## TLE986xQX Family - BE-Step

## TLE987xQX Family - BE-Step

### Overview

This document lists the errata of the TLE986xQX family and the TLE987xQX family, for related products please refer to [Table 2](#).

**Figure 1 Example IRAM settings for the TLE9871QXA20**

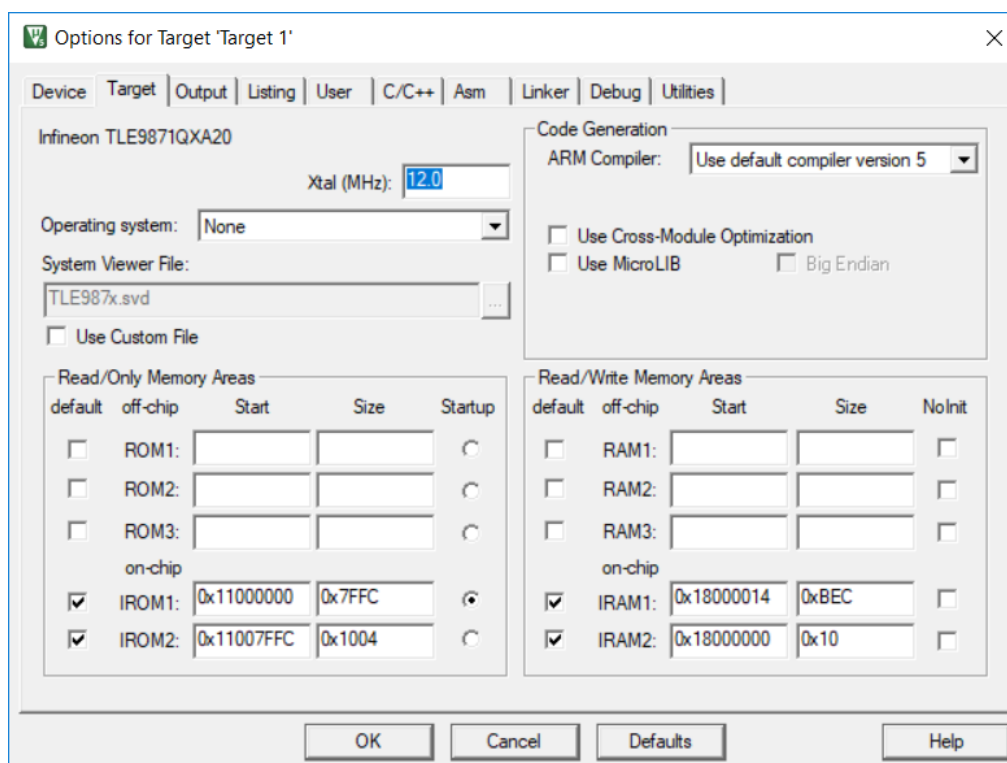
The function USER\_NVM\_ECC\_CHECK uses for its operation 32 bytes on the user stack plus 1 byte in user RAM at address 0x18000011, this is not clearly specified in the BootROM User Manual.

Adjust the project IRAM settings to exclude this address from the RAM area usable by the linker. In order to maintain memory alignment a hole of four bytes, from 0x18000010 to 0x18000013 is recommended. **Figure 1** displays an example for the TLE9871QXA20. **Table 3** lists the recommended IRAM settings for each device.

Fix with next user documentation update.

Figure 4 Register view of specified SHPR2 register

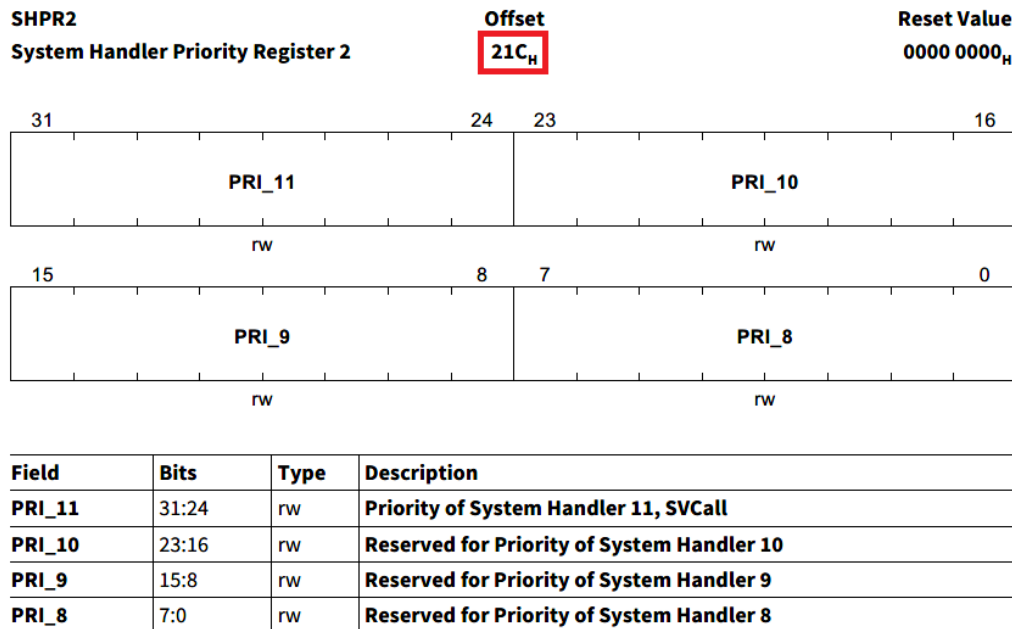
The address of the register SHPR2 is specified wrongly.

Figure 5 Register view of implemented SHPR2 register

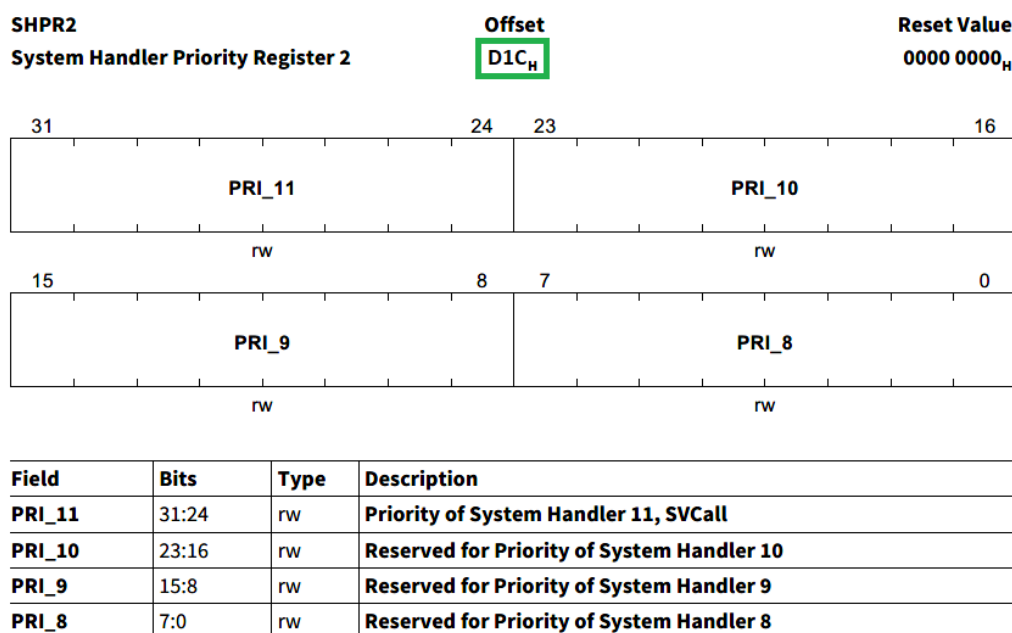
The implemented address for the register SHPR2 is 0xE000ED1C.

Fix with next user documentation update.
